Vermont Agency of Transportation
RECEIVED
 CK'D BY JG, RF OK'D BY GL
 February 2, 2016
 RESUBMIT YES Rejected
 BY KH DATE 2-23-2016

GUARD RAIL TO BRIDGE RAIL TRANSITION

SPECIAL PROVISION, GRAS - CONCRETE COMBINATION BR.
 ROUTE NO. T.H. 3 (CLASS 2), RURAL COLLECTOR, BRIDGE # 11
 TOWN OF CLARENDON, RUTLAND COUNTY, VT.

ITEM #: 900.620 SHEET 9 OF 9

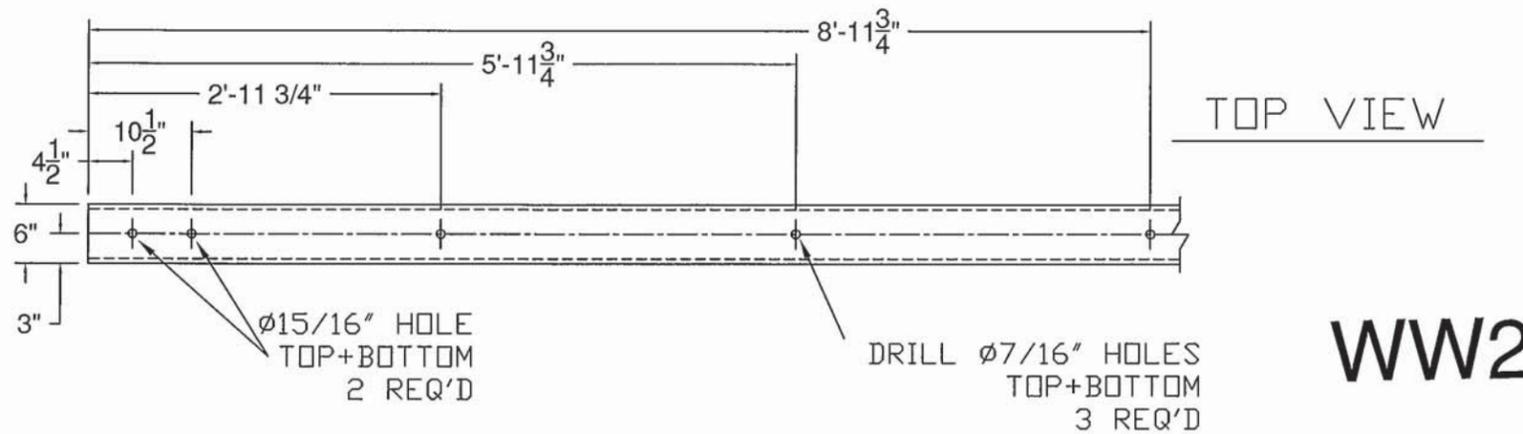
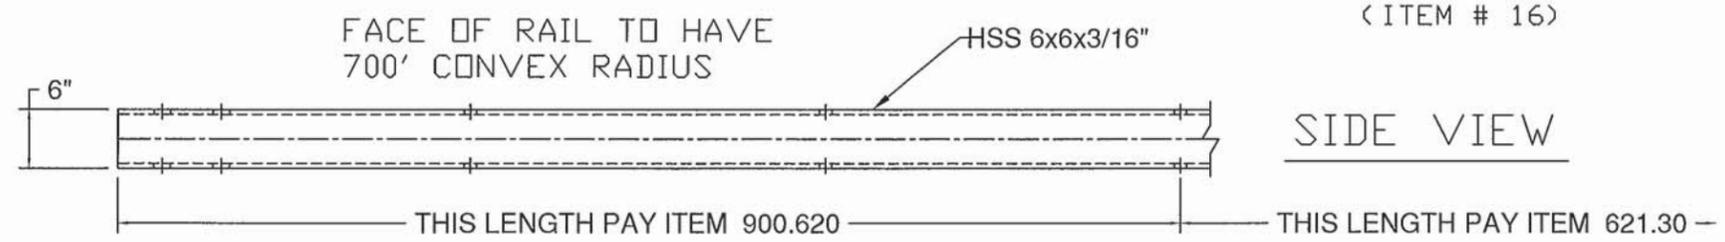
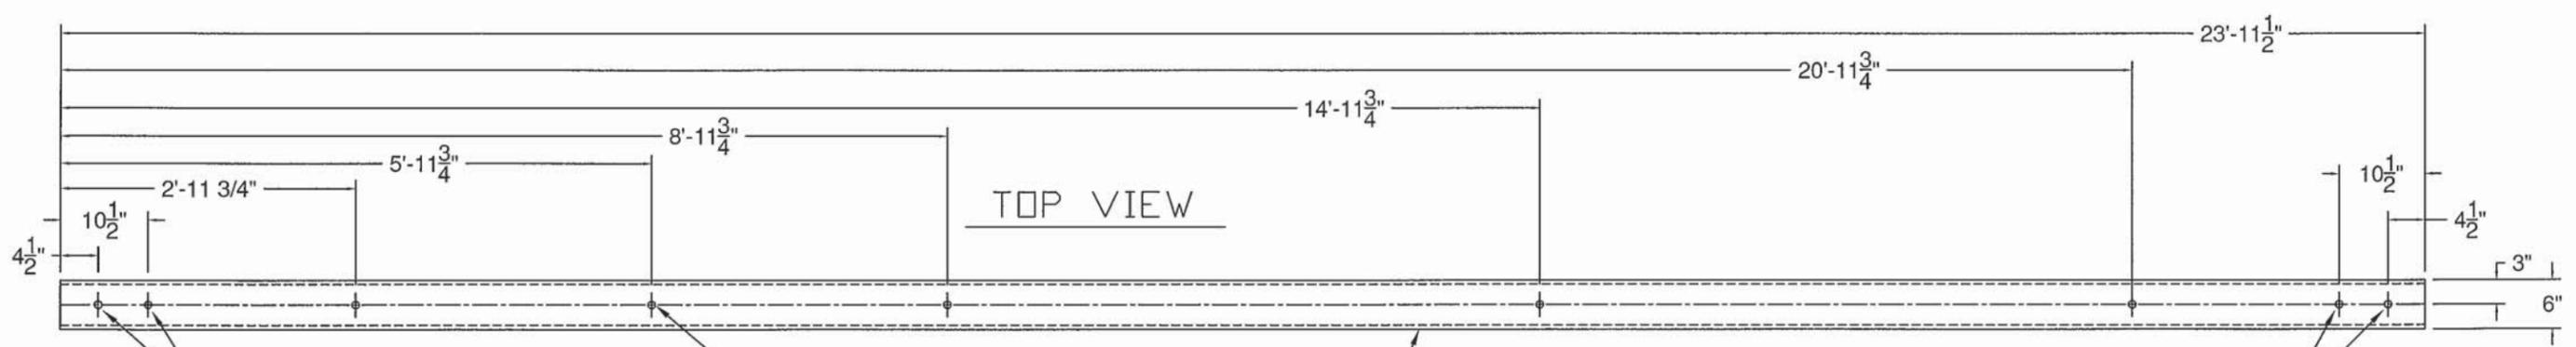
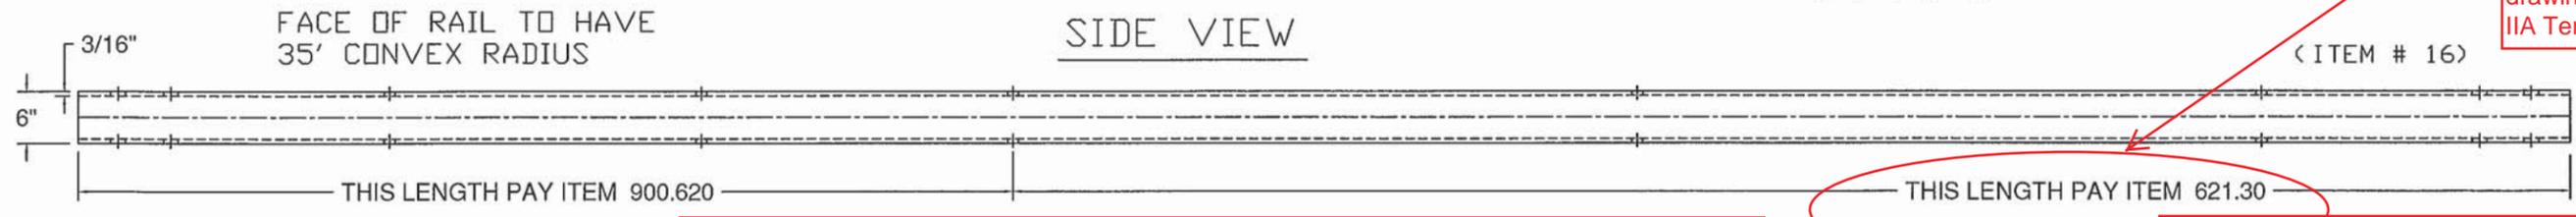
The Length of Rail to be paid under Item 900.620 Special Provision (Type IIA Terminal). Separate Fabrication drawings will be required for the Type IIA Terminal End Assembly.

Please see Type IIA details (Sheet 26) of Contract Plans for Post Spacing and rail curvature.

Label as Item 900.620 Special Provision (Guardrail Approach Section to Concrete Bridge Railing).
